New Wee Waa High School (SSD - 21854025) Response to Submissions

RE: New Wee Waa High School (SSD-21854025) – Public Authority Consultation (PAE-40130687)

Response to Submissions SSD21854025: Lot 124 & 125 DP 757125, Lot 2 DP 550633 and Lot 1 DP 577294, Mitchell Street (HW29), Wee Waa, Wee Waa High School

Figure 1 Amended site layout showing relocation of parking and Indigenous cultural centre

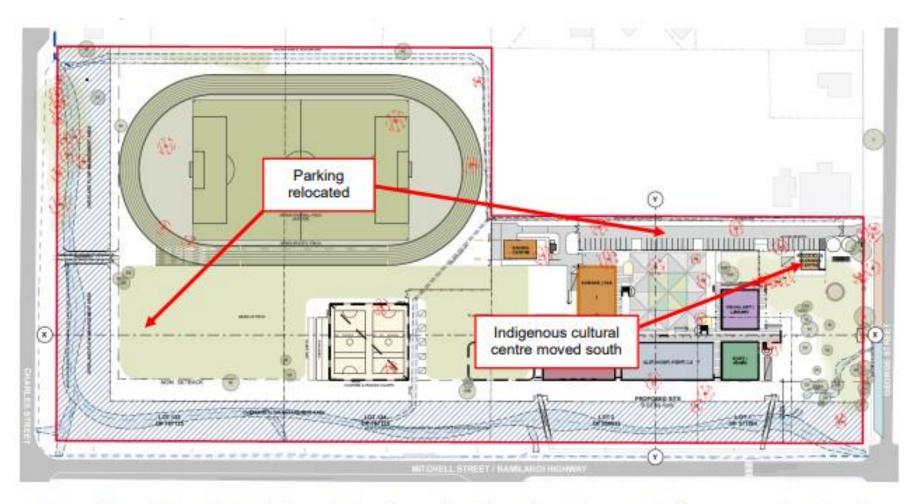
2. Development footprint for the State Significant Development application

Clearance of native vegetation within the flood conveyance channel, playing fields and courts is treated in the SSD application as having been covered by a Part 5 determination (pending).
